SUBDIVISION REVIEW SHEET

CASE NO.: C8-2022-0318.0A

SUBDIVISION NAME: Maxwell Subdivision

**CITY OF AUSTIN –DEVELOPMENT SERVICES DEPARTMENT
SUBDIVISION APPLICATION – MASTER COMMENT REPORT**

FINAL PLAT MAXWELL SUBDIVISION

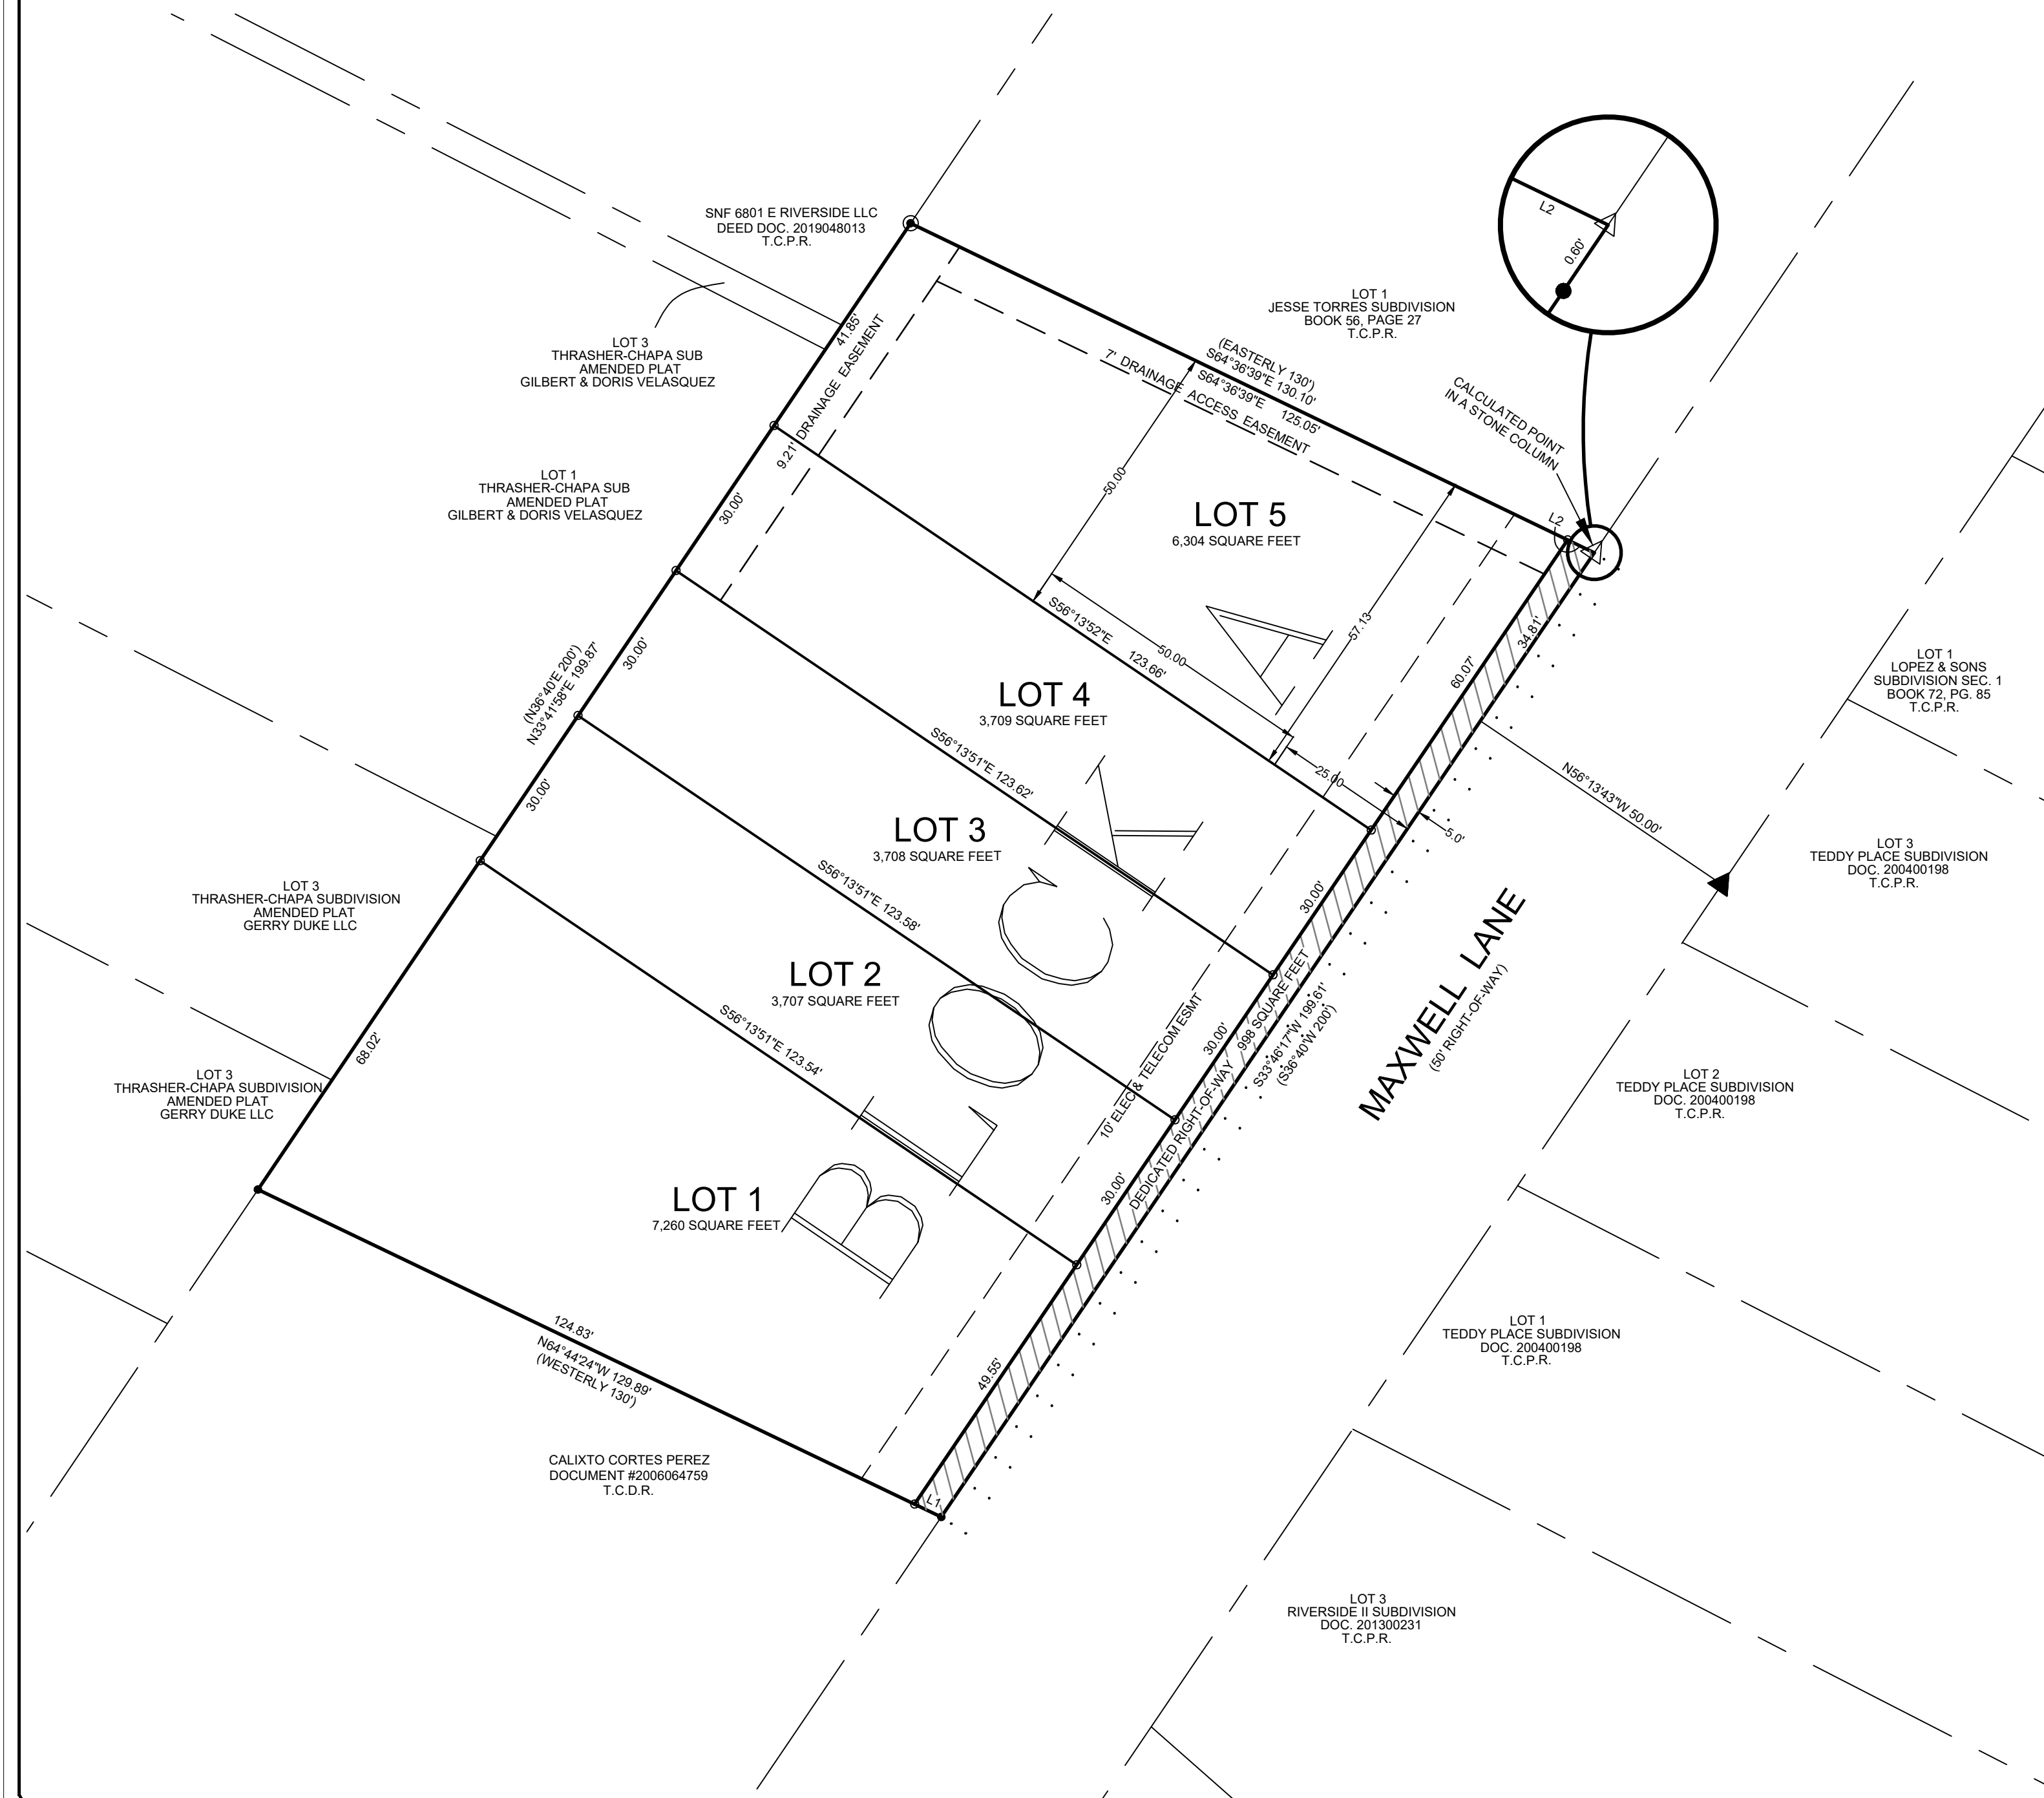
Please confirm that proposed 10' electric easement is directly adjacent to the newly dedicated ROW, and show this on plat.

- ATD 3. The ASMP requires **58 feet** of right-of-way for Maxwell Lane. Dedicate 29 feet of right-of-way from the centerline in accordance with the ASMP (LDC 25-6-55). Please specify the length of right-of-way.

- ATD 4. A sidewalk easement is required if the public sidewalk enters onto private property. Provide an additional two feet within the easement for maintenance purposes. TCM, 4.1.1, 4.1.2. (*Determine if the sidewalk easement requires maintenance (i.e. "with maintenance"). Otherwise add 2-additional feet*). Please clarify whether this sidewalk enters private property.

- ATD 5. Show the standard sidewalk detail (COA Standard No. 432S-1, adopted 3/26/2008).

- SR 3. Show all existing easements on the plat, annotate easements accordingly if provided by separate instruments. (L.D.C 25-1-83)
- SR 4. Include the case number on the lower right corner of each plat sheet, C8-2022-0318.0A. (LDC 25-1-83)

- SR 5. Verify the scale on the plat measures correctly to avoid future amendments on the plat during the residential permitting or site plan phases. (L.D.C 25-1-83)
